PAVING PLAN

PHASE 1 - KAUMUALII HIGHWAY
LIHUE MILL BRIDGE TO RICE STREET

PHASE 3 - REHABILITATION OF LIHUE MILL
BRIDGE AND MAKAI WIDENING

AS-BUILT

| SHEET No. C-39 OF 82 SHEETS                                          |                                                     |

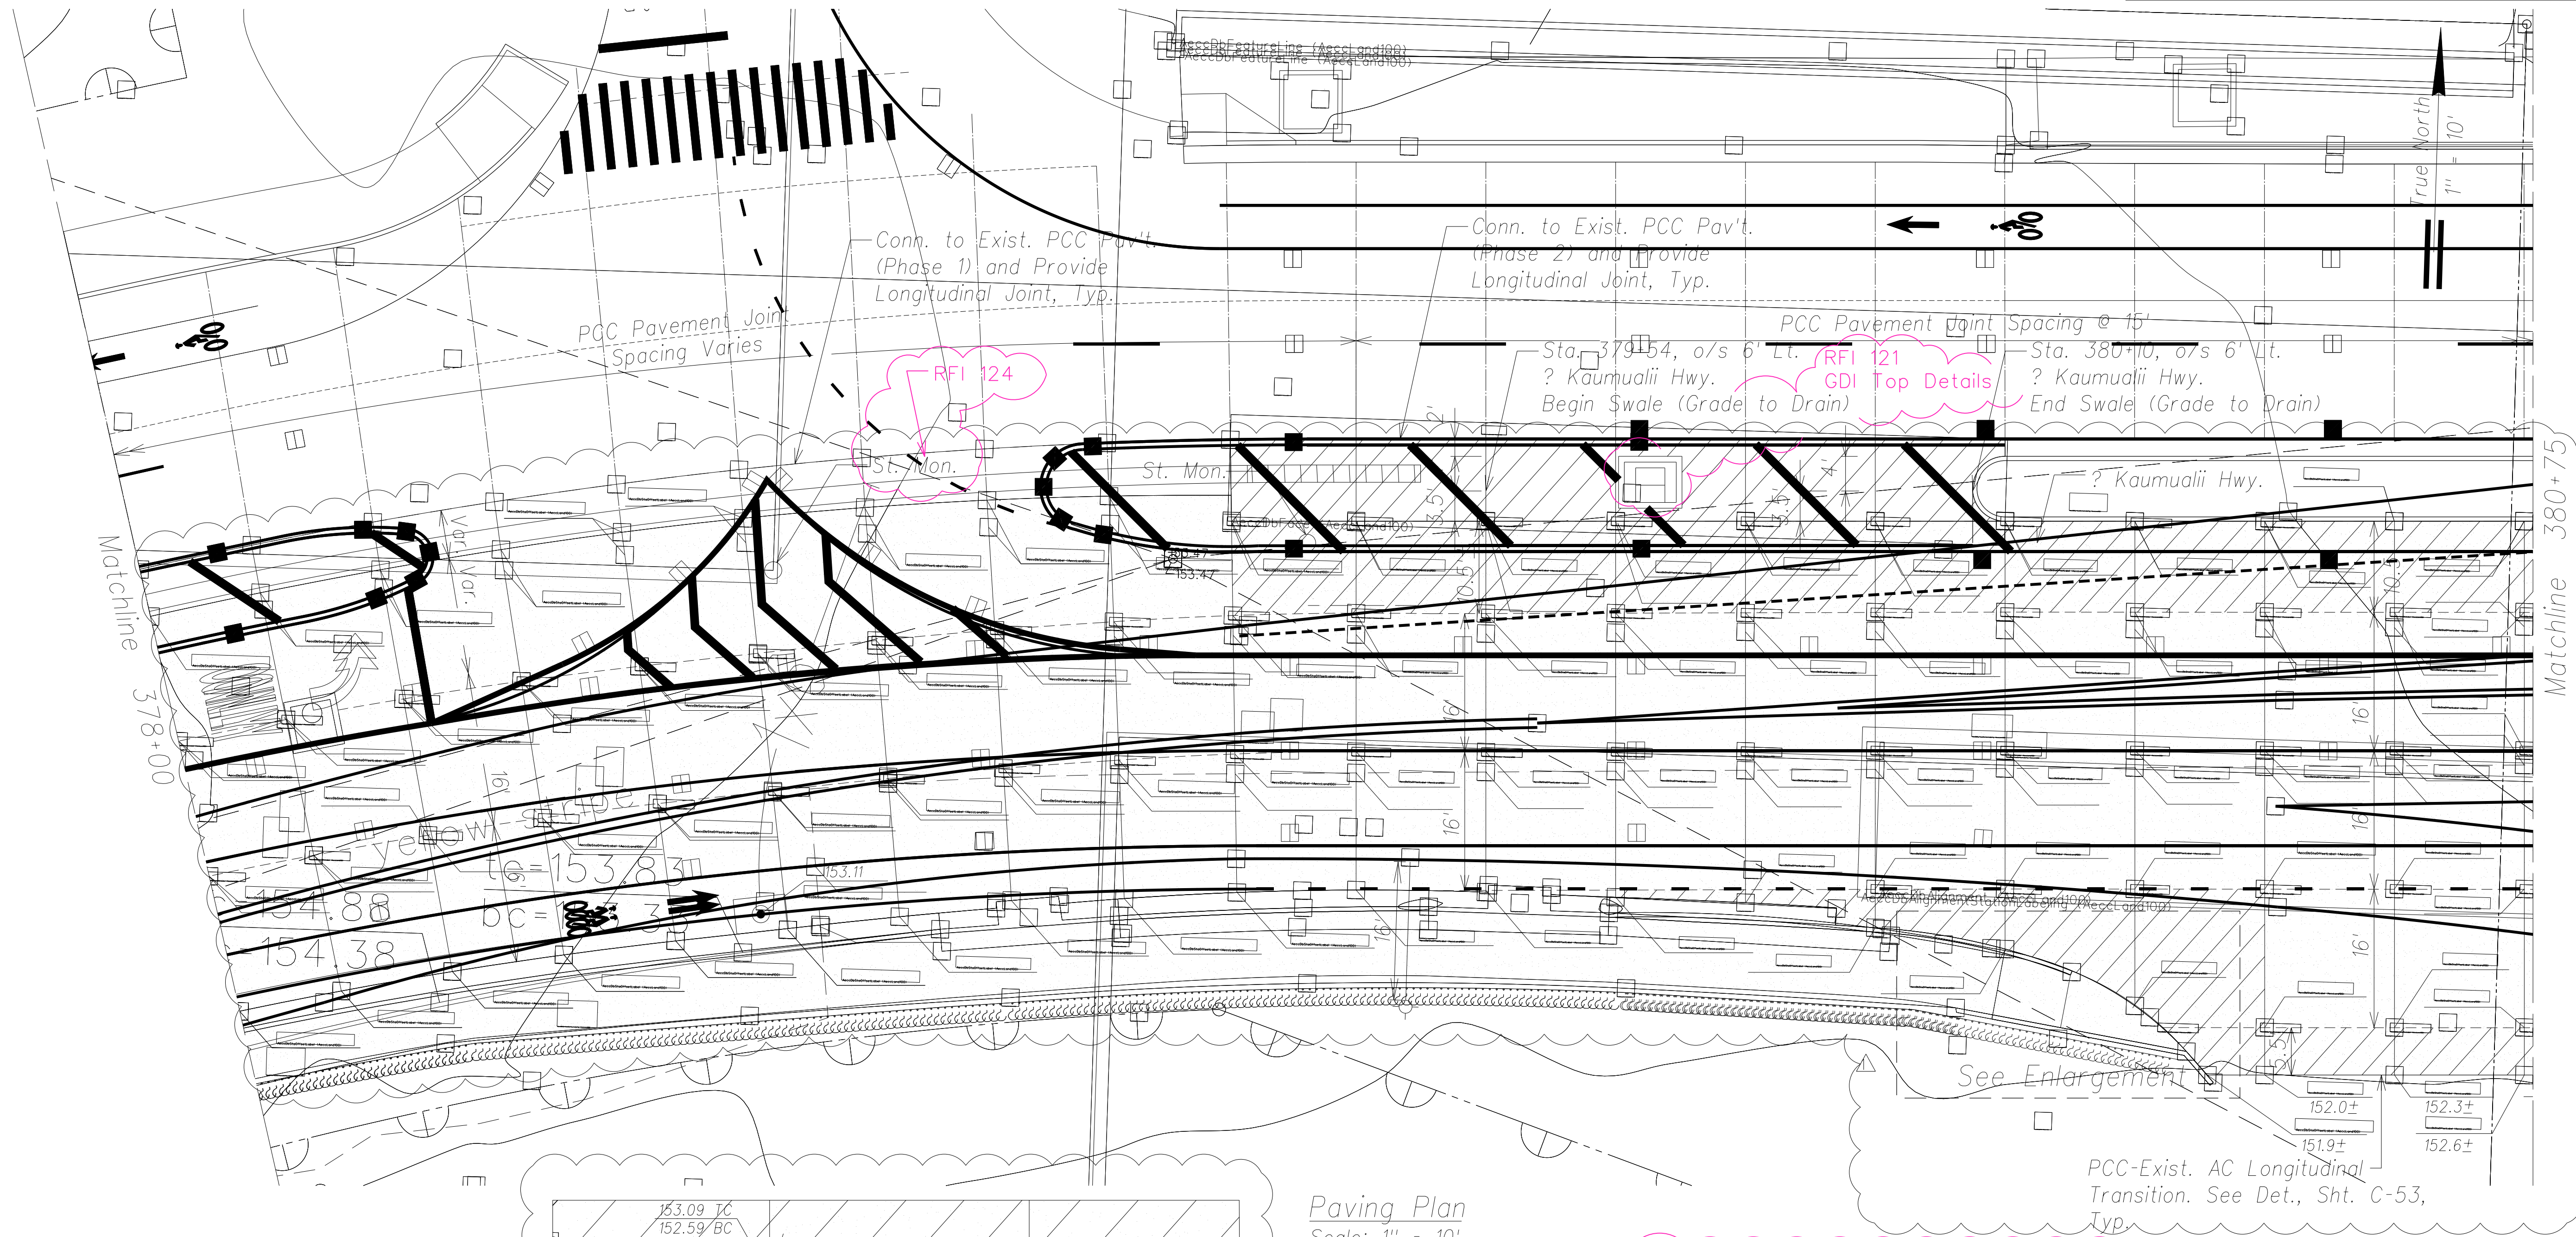
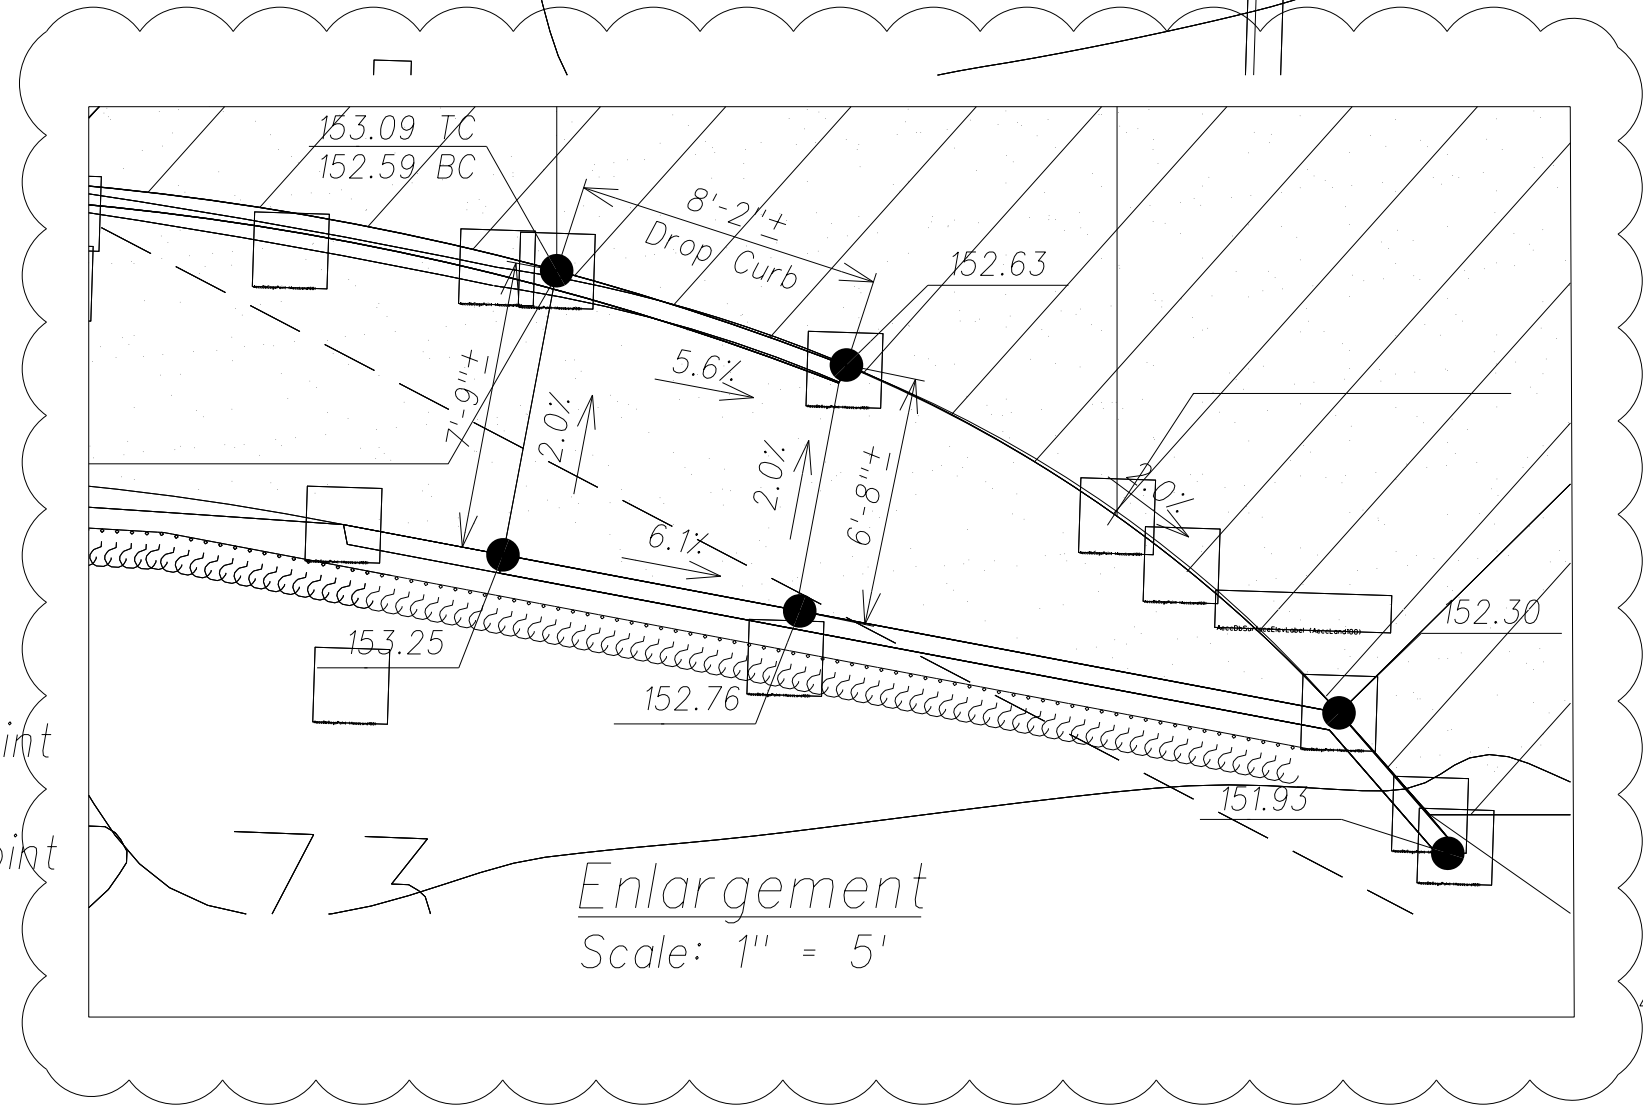
- RFI 116 - PCC-AC Travelway Transition
- RFI 115 - Subbase Section Change From 380+14 to 384+384+58
- RFI 124 - Survey Monument Core Holes
- RFI 121 - GDI top Details

| 4/6/15                                                               | Rev. for add'l PCC pav't and sidewalk. Add st. mon. |
